SUBJECT: GEAR WARNING CIRCUIT & THROTTLE SWITCH MODIFICATION

AFFECTED: MOONEY M20J, S/N 24-3201, 24-3218 THRU 24-3402  
MOONEY M20M, S/N 27-0001 THRU 27-0229  
MOONEY M20R, S/N 29-0001 THRU 29-0110

FIGURE SI M20-103-1

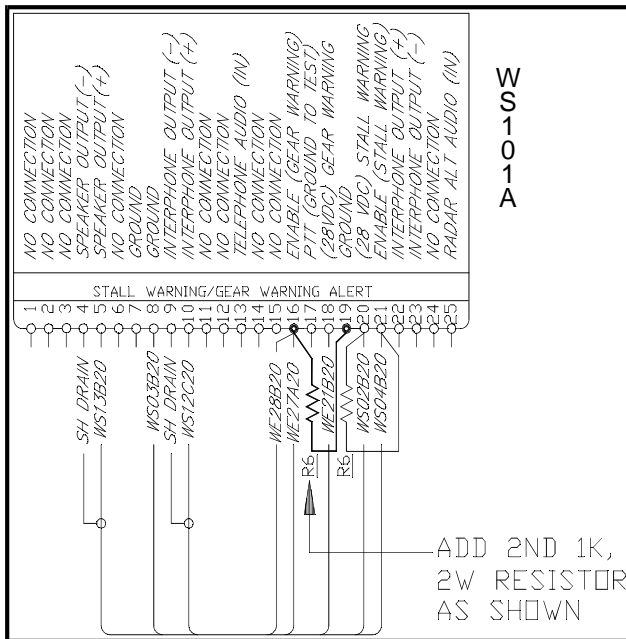
3. Reference schematic shown in Figure SI M20-103-1 and solder the MIL-R-11-RC42, 1K 2W resistor, (Allen-Bradley P/N RC42-GF102J, included in kit) between the designated pins (16 - ENABLE-GEAR WARNING and 19 - GROUND). The resistor must be positioned so it will not interfere with the connection of the wire harness back to the Tone Generator. Protect resistor with heat shrink or other insulation.

FIGURE SI M20-103-2

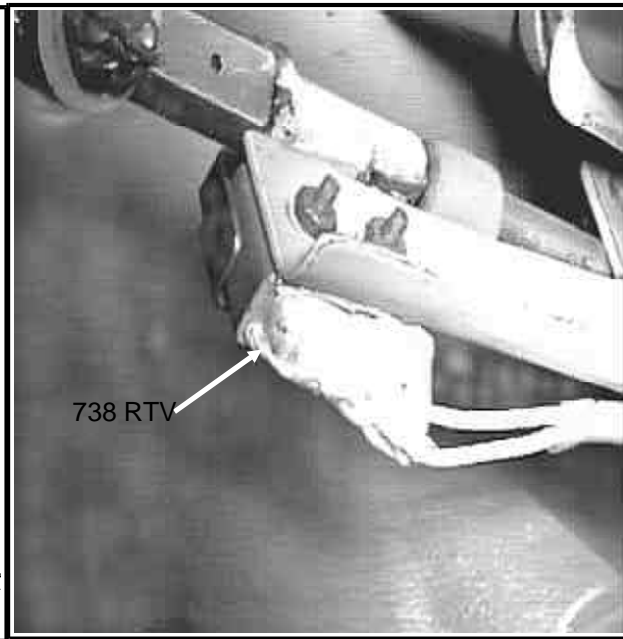
6. Inspect wire leads at switch for sealant covering wire/switch connection area. If sealant is found, verify integrity of sealant application over wire and switch connections.

7. If no sealant is found or integrity is compromised, apply Dow Corning 738 RTV Silastic Sealant, covering wire/switch connections completely. Switch is Micro Switch P/N 1SE1-T. Reference Figure SI M20-103-2.

FIG. SW101A

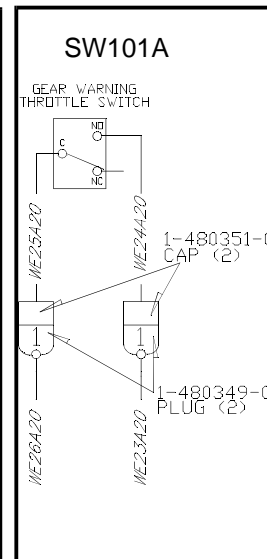
8. Locate 4 Pin Plug, RC04A/PL04A (on rear engine baffle) and replace with 2 each connectors, AMP P/N 1-480351-0 Cap (toward switch) and 1-480349-0 Plug. Reference Figure SI M20-103-3 & -4 for identification of wire numbers to change to AMP connectors. Discard clamp used on this 4 Pin Plug/Receptacle.
